ADDENDUM NO. 3
to
PLANS and SPECIFICATIONS
for

Medina River Sewer Outfall, Segment 4
SAWS Job No. 12-2504

Issue Date: November 30, 2011

JOB NO.	6866-00
DATE	FEBRUARY 2010
DESIGNER	RRD
DRAWN	BMO
CHECKED	LJC
DRAWING No.	C-71
SHEET No.	12

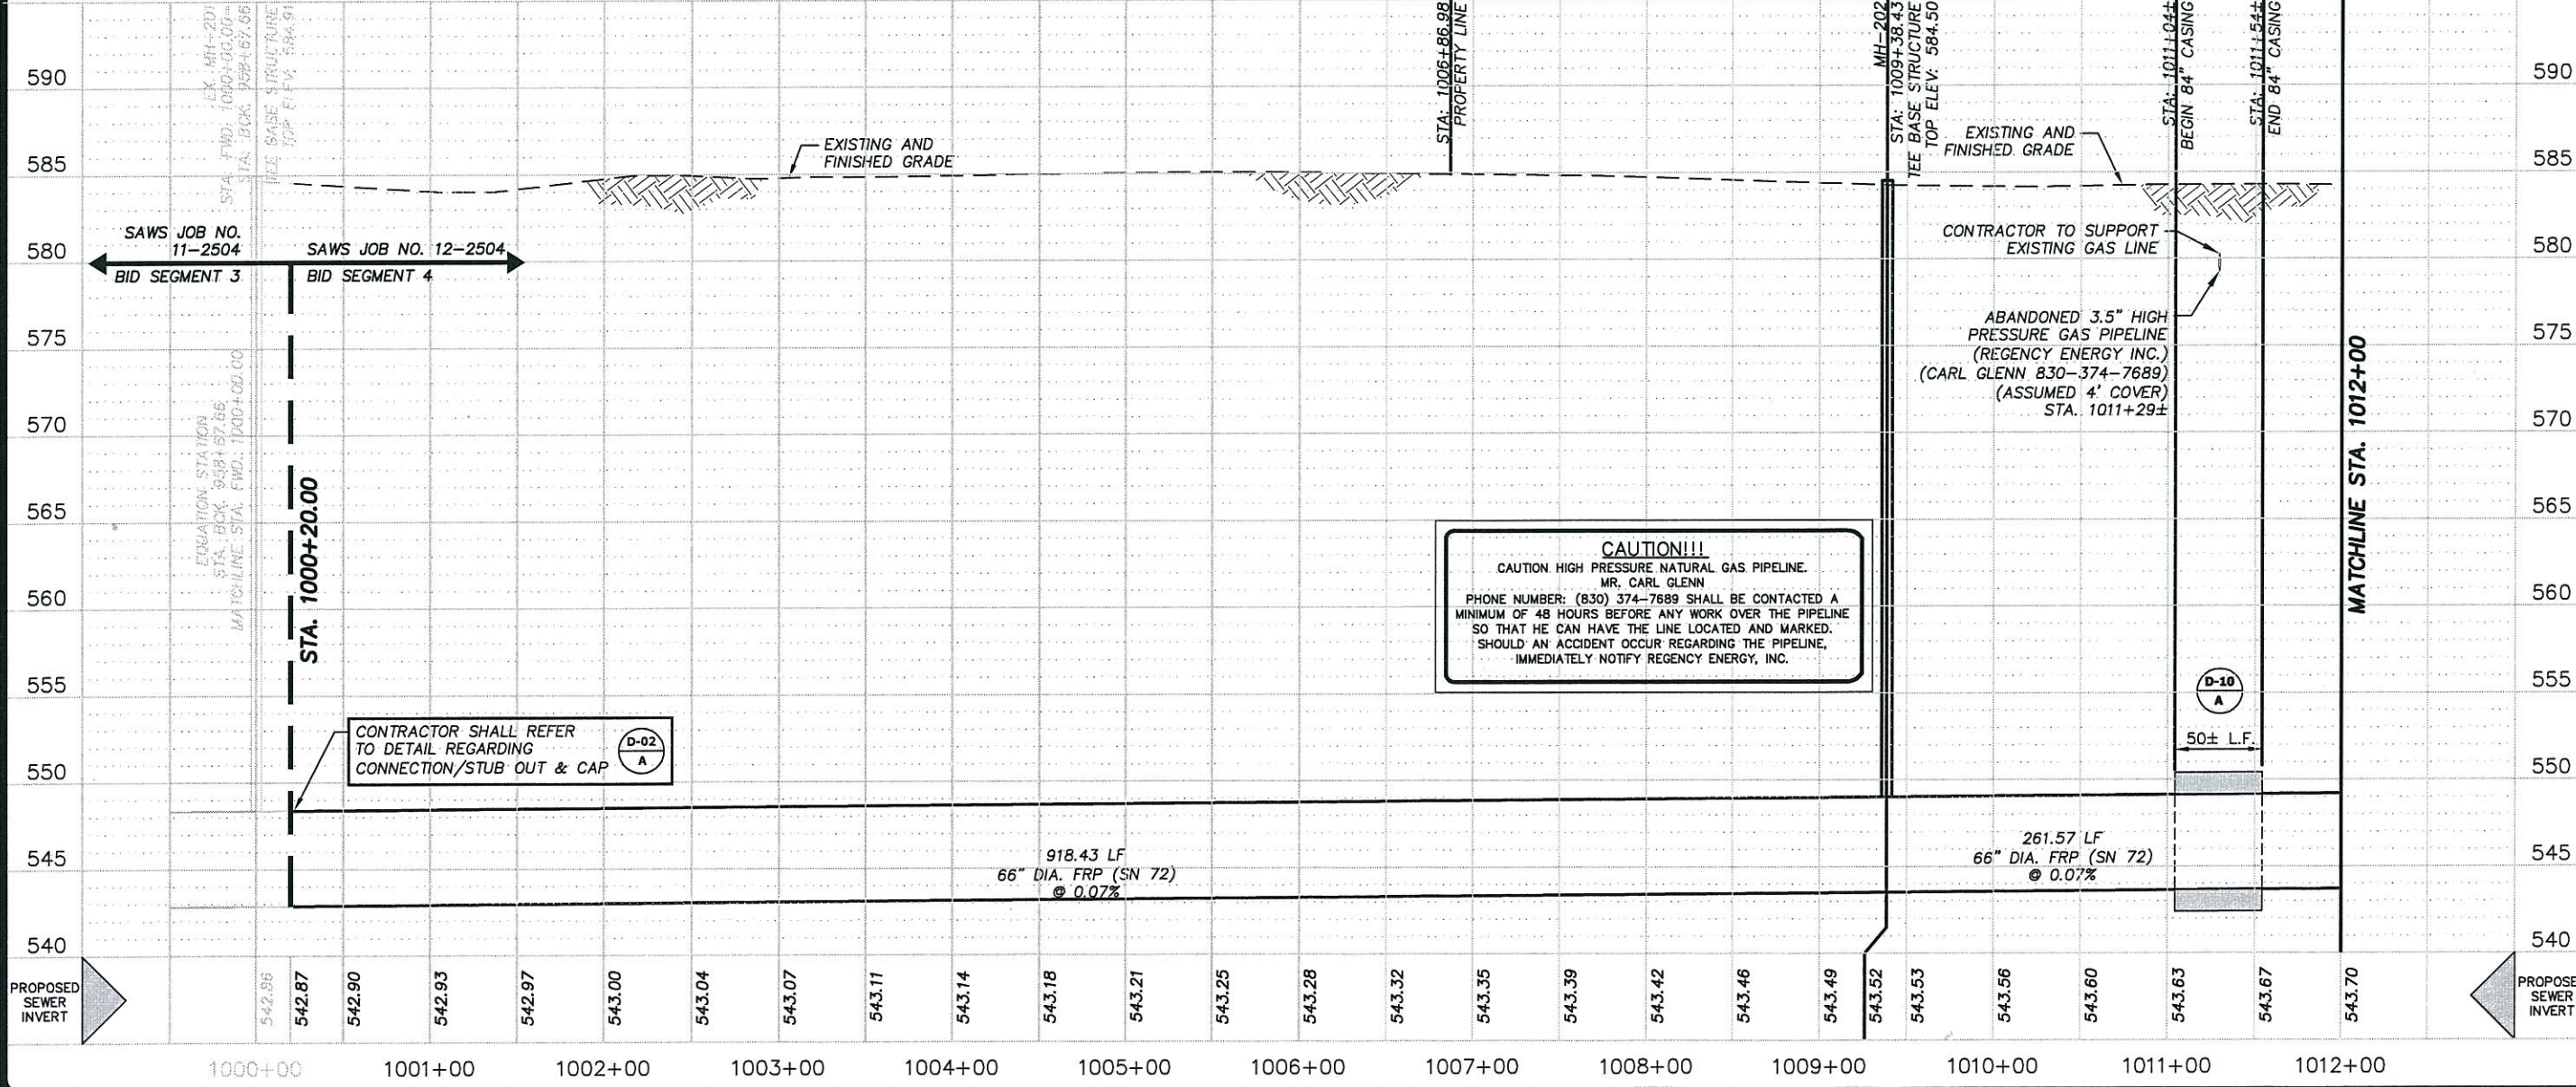
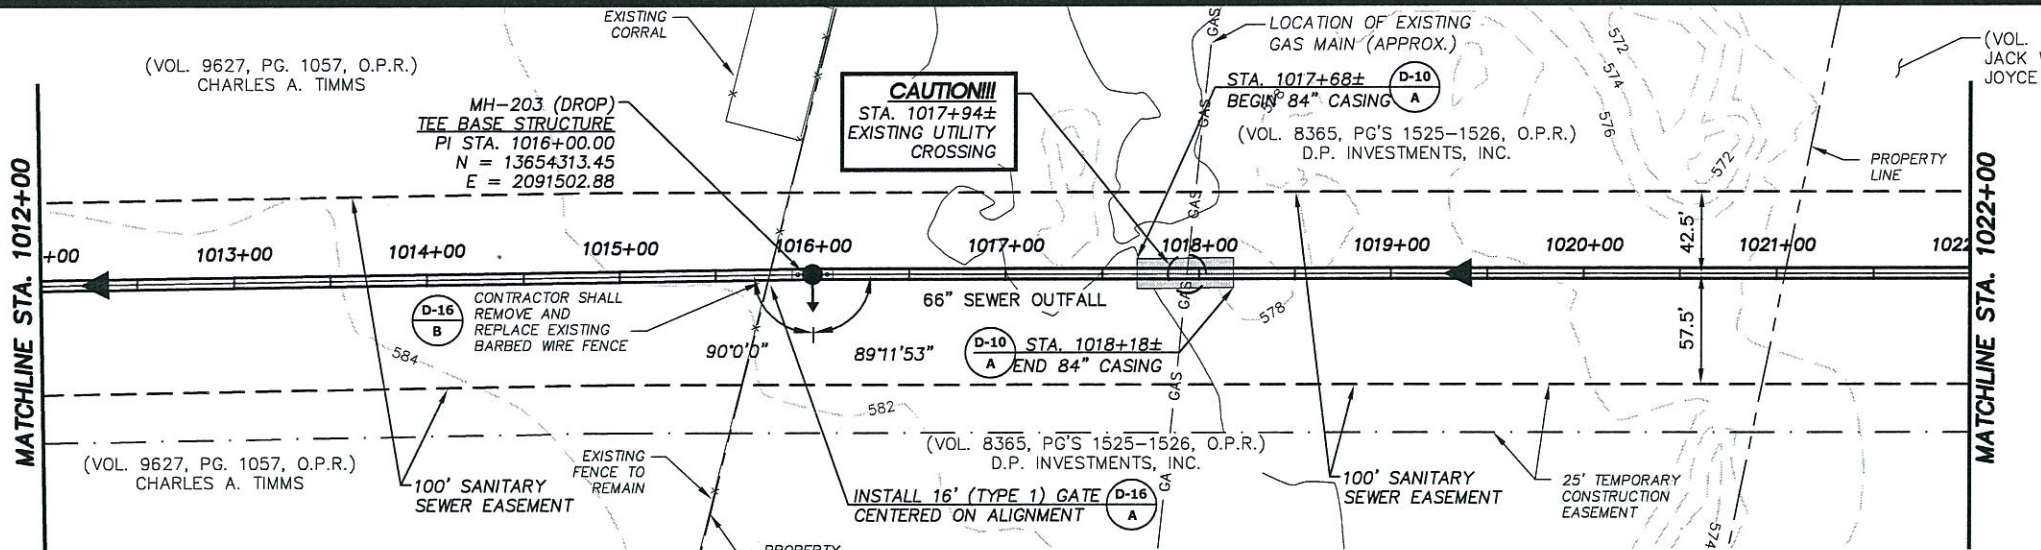
- A. Drawing No. G-01, Sheet No. 02 – Revised to reflect the new quantities. Remove and Replace this sheet with the attached plan sheet.
- B. Drawing No. C-71, Sheet No. 12 – A bore has been added under gas line to plans and contact number has been revised in note. Remove and Replace this sheet with the attached plan sheet
- C. Drawing No. C-72, Sheet No. 13 – A bore has been added under gas line to plans and contact number has been revised in note. Remove and Replace this sheet with the attached plan sheet.
- D. Drawing No. C-73, Sheet No. 14 – A bore has been added to plans and contact number has been revised in note. Remove and Replace this sheet with the attached plan sheet.

JOB NO.	6866-00
DATE	FEBRUARY 2010
DESIGNER	RRD
DRAWN	BMO
CHECKED	LJC
DRAWING No.	C-74
SHEET No.	15

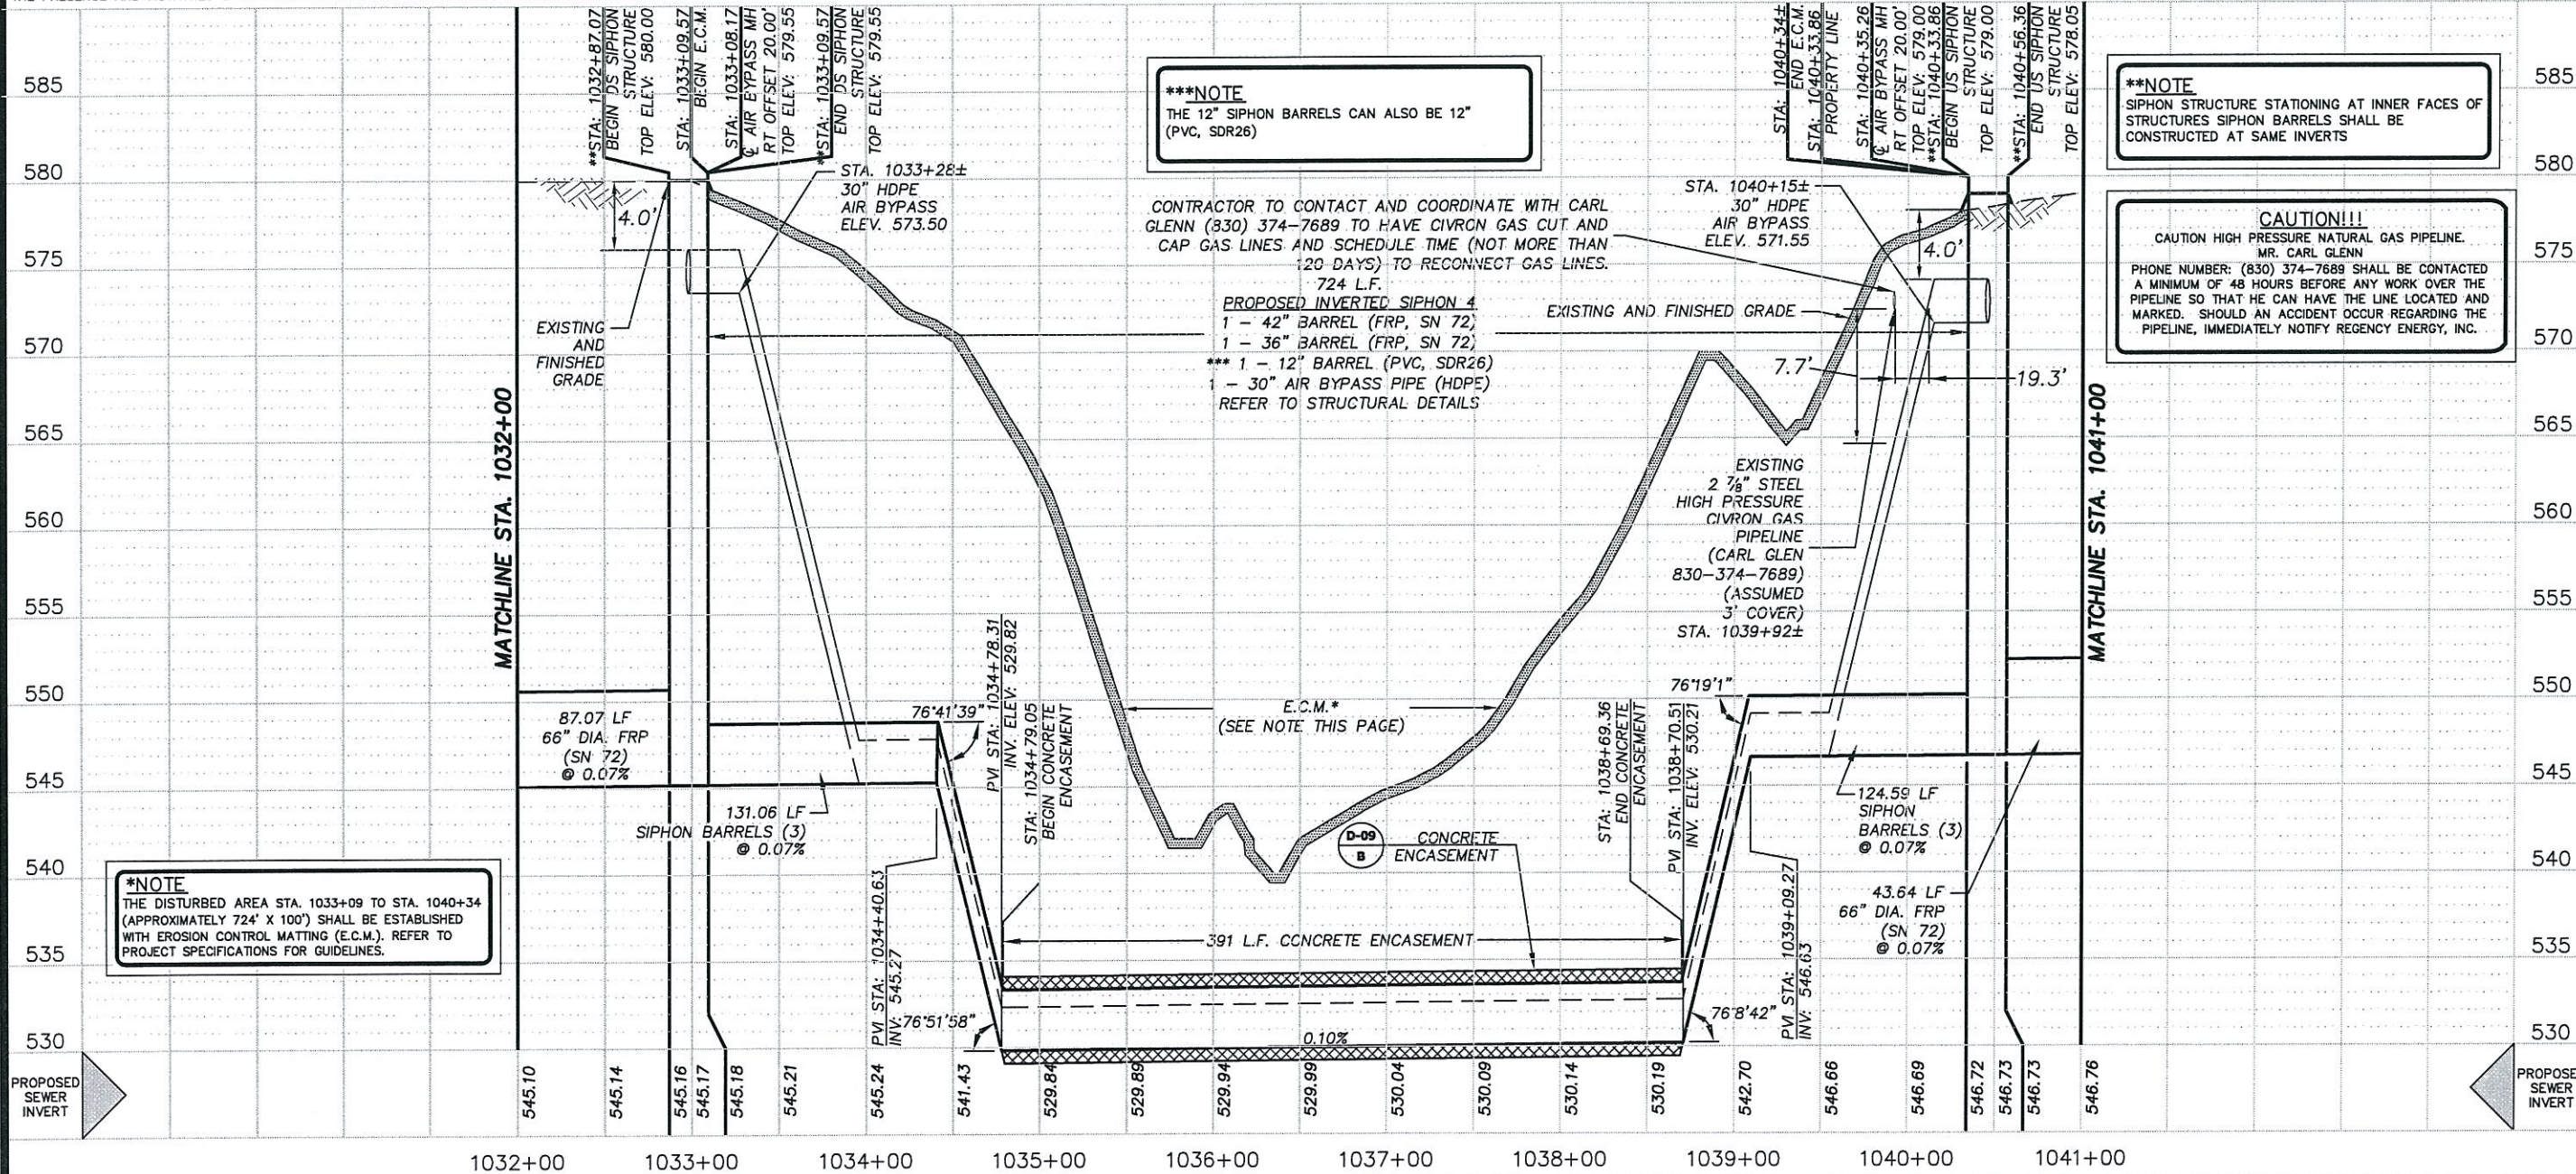
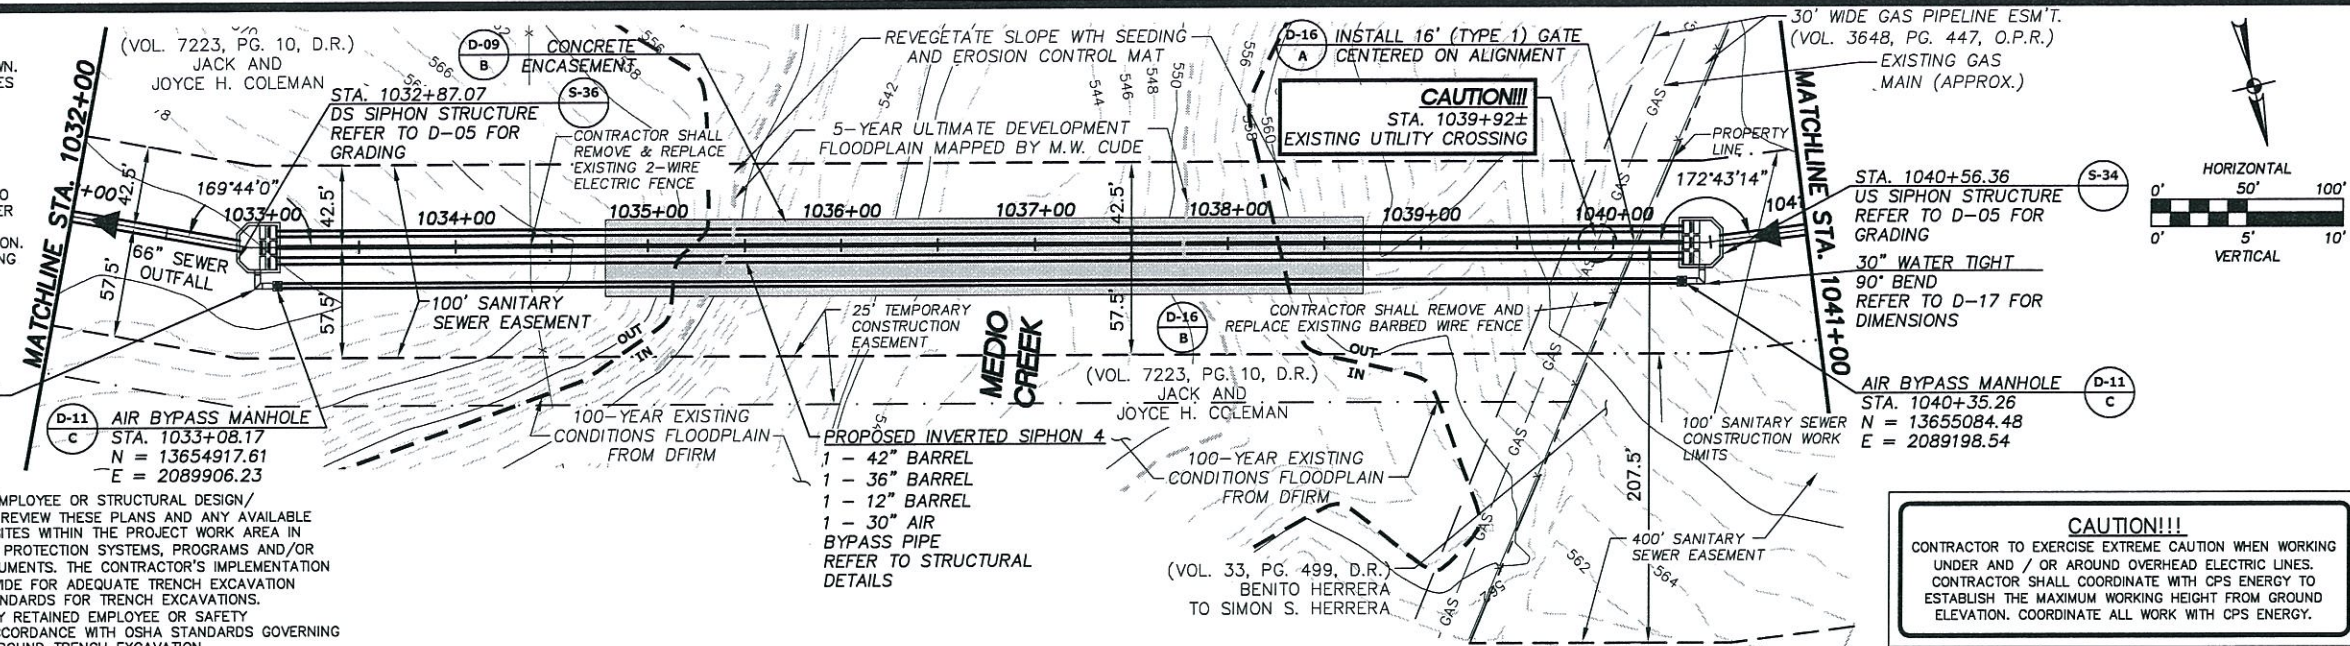
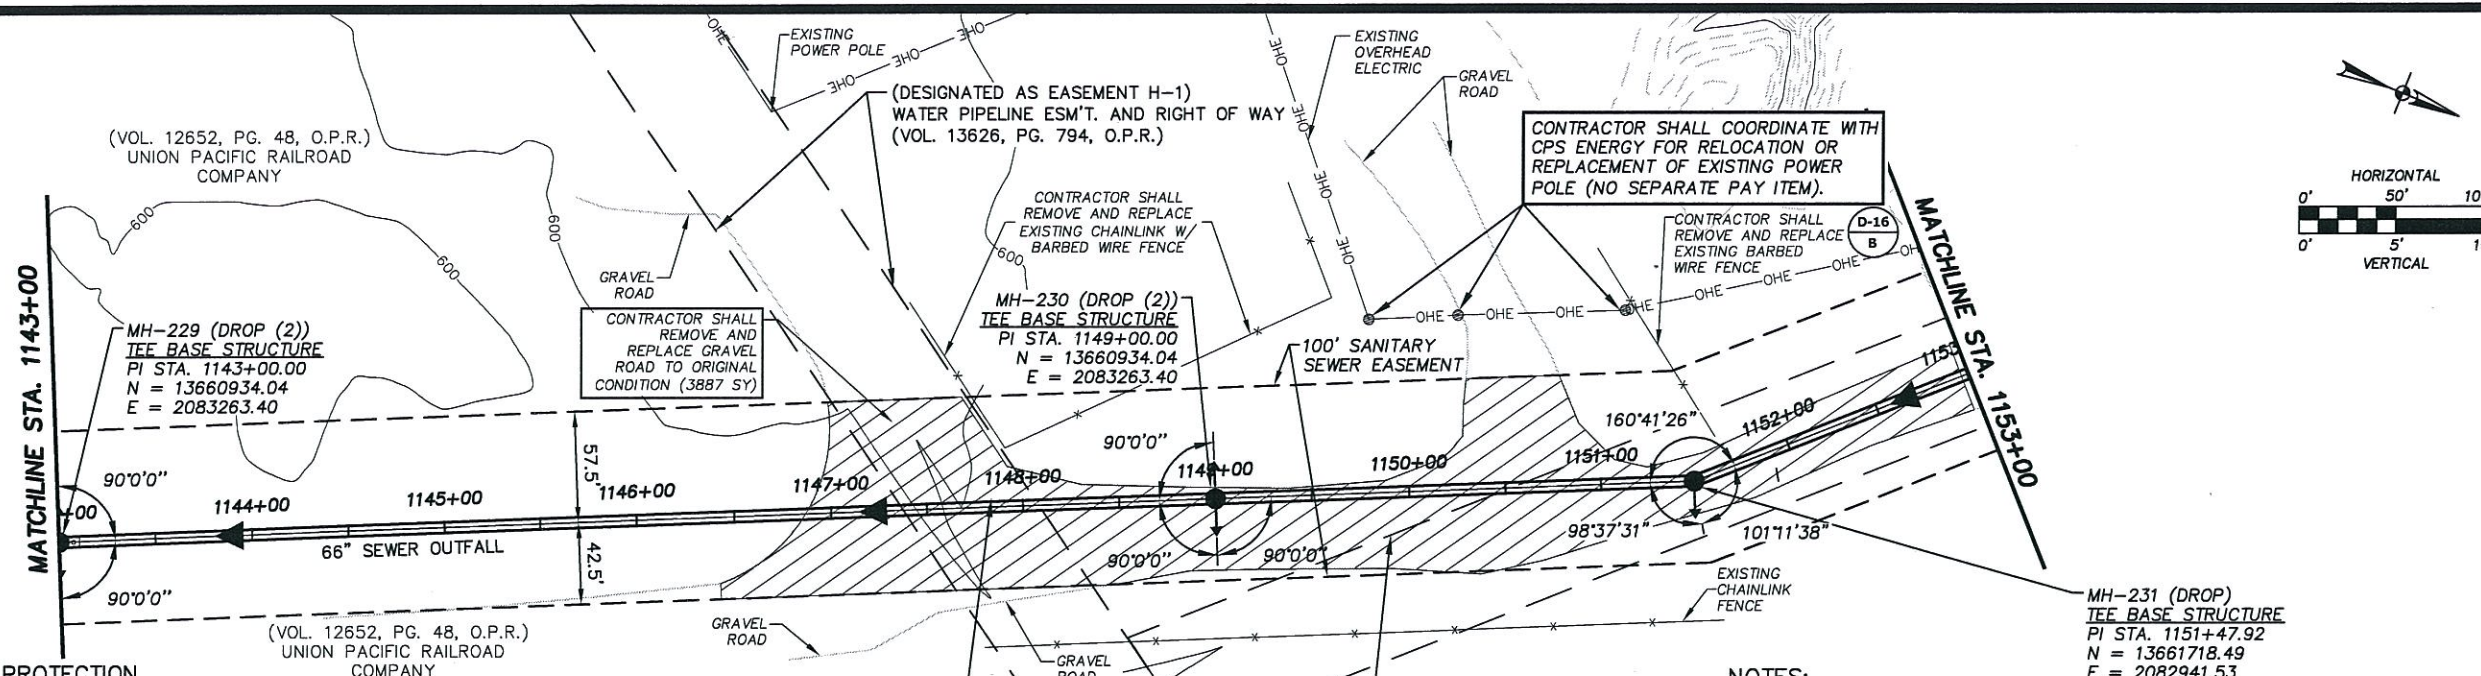
- E. Drawing No. C-74, Sheet No. 15 – Added note to plan for gas line crossing requirements. Added hatching for concrete encasement on plan view. Remove and Replace this sheet with the attached plan sheet.

RR. Question: Drawing no. C-74. Please define the limits of re-vegetative seeding and erosion control mat required.

Answer: Contractor to refer to note on bottom left of Drawing C-74, Sheet No. 15.
